Case No.: 94-06-304C
Community: City of Albuquerque,
New Mexico
Community No.: 350002

In a letter dated June 17, 1994, Ms. Jackie S. McDowell, P.E., Consulting Civil Engineer, requested that we issue a Letter of Map Amendment for Lot 29, Block 6, Tract 2, Unit 1, North Albuquerque Acres, in the City of Albuquerque, New Mexico. Ms. McDowell submitted our standard Property and Elevation Information Forms, the recorded deed for the property, a grading plan entitled, "North Albuquerque Acres, Lot 29, Block 6, Tract 2, Unit 1," dated May 1994, prepared by McDowell Engineering, Inc., and supplemental hydrologic and hydraulic calculations. The property in question is shown to be in a Special Flood Hazard Area (SFHA) on the Flood Insurance Rate Map (FIRM) for the City of Albuquerque, New Mexico (National Flood Insurance Program (NFIP) Map Number 350002, Panel 0011 C), and designated Zone AO (depth 1 foot). This area has been identified as being subject to alluvial fan flooding.

DRAINAGE PLAN FOR NAA, LOT 29, BLOCK 6, TRACT 2, UNIT 1 (C22-D39)
ENGINEER'S STAMP DATED 5/12/94.

BERNALILLO COUNTY		NEW MEXICO	
NORTH ALBUQUERQUE ACRES LOT 29, BLOCK 6, TRACT 2, UNIT 1			
HOPKINS NAA LOT - GRADI

Alternate Flow Paths

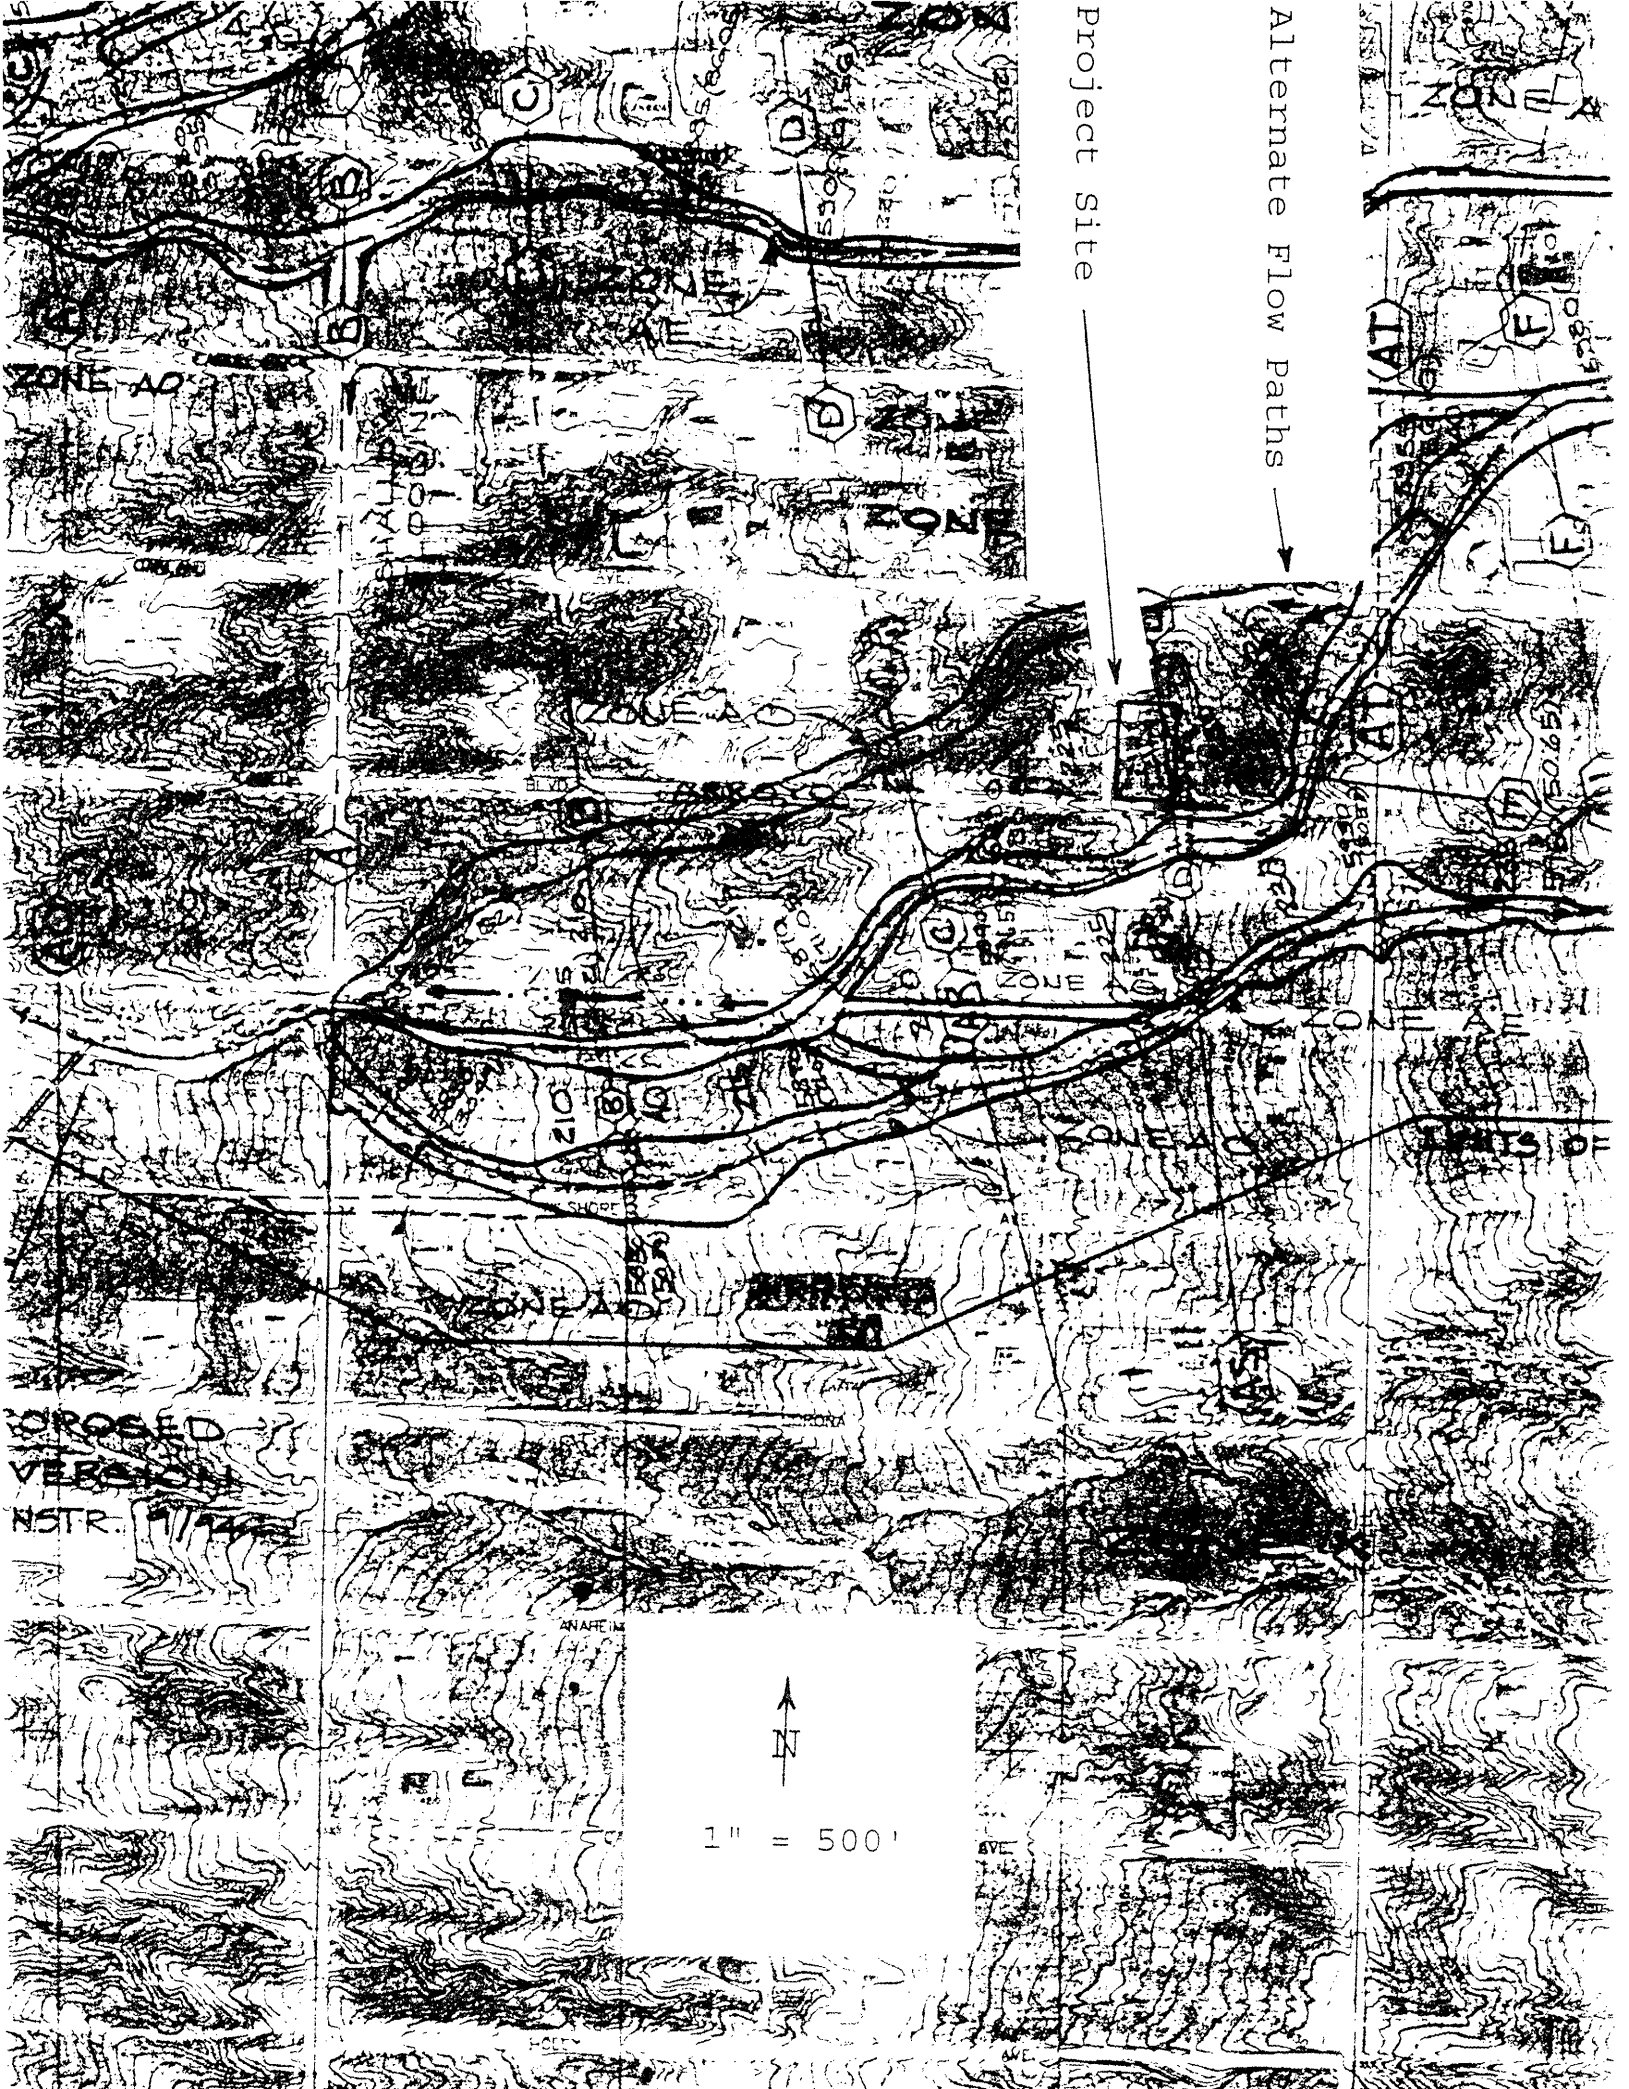
In addition, a preliminary review of the topographic work maps indicate possible alternate or multiple flow paths through your project site, indicating that the flow may not be confined to a single channel as shown on the revised floodplain map (see enclosed map). As stated above, this is common in areas subject to alluvial fan flooding, and needs to be addressed in any future submittal for this site, as stated in Section 65.13 of the NFIP regulations.
